# Access Compliance Report

## Public Rights-of-Way

### (Curb Ramps)

Intersection ID: 48863	Main Street: STEELE_CREEK_RD	Cross Street: WALKER_BRANCH_DR	Location: SW
ADA ID: 121BFB590B66	Ramp Type: Perp	Initial Pass/Fail: Fail	Overall Compliance: No
Severity Score: 8.75			
Codes/Mitigation Info/Possible Solution		Field Measurements/Component Compliance

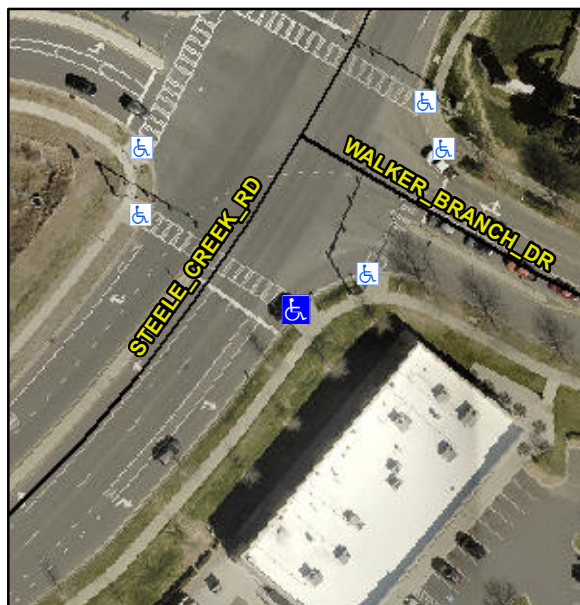
**Not Found, R304.5.1**

Compliance	Description	Data	Compliance	Description	Data
N/A	Ramp Length (in)	95.0	Yes	Ramp Slope (%)	6.2
No	Ramp Width (in)	42.5	Yes	Ramp XSlope (%)	0.3
N/A	Flare Type LT	N/A	N/A	Flare Type RT	N/A
N/A	Flare Slope LT (%)	N/A	N/A	Flare Slope RT (%)	N/A
N/A	Flare Traversable LT?	N/A	N/A	Flare Traversable RT?	N/A
N/A	Landing Length (in)	N/A	N/A	DWS Provided?	N/A
N/A	Landing Width (in)	N/A	N/A	DWS Contrast?	N/A
N/A	Landing Slope (%)	N/A	N/A	DWS Length (in)	N/A
N/A	Landing X Slope (%)	N/A	N/A	DWS Full Width?	N/A
N/A	Landing Curb? (Y/N)	N/A	N/A	DWS Offset (in)	N/A
N/A	Shared Landing?	N/A			
N/A	Gutter Ponding?	N/A	N/A	Gutter Slope (%)	N/A
N/A	Gutter Lip Ht (in)	N/A	N/A	Gutter X Slope (%)	N/A
N/A	Painted X Walk1?	Yes	N/A	Painted X Walk2?	N/A
	X Walk 1 Direction	To NW		X Walk 2 Direction	N/A
N/A	X Walk 1 Width (in)	111.0	N/A	X Walk 2 Width (in)	N/A
	X Walk 1 Slope (%)	1.3		X Walk 2 Slope (%)	N/A
	X Walk 1 X Slope (%)	2.4		X Walk 2 X Slope (%)	N/A

**Remove & Replace Entire Ramp.**
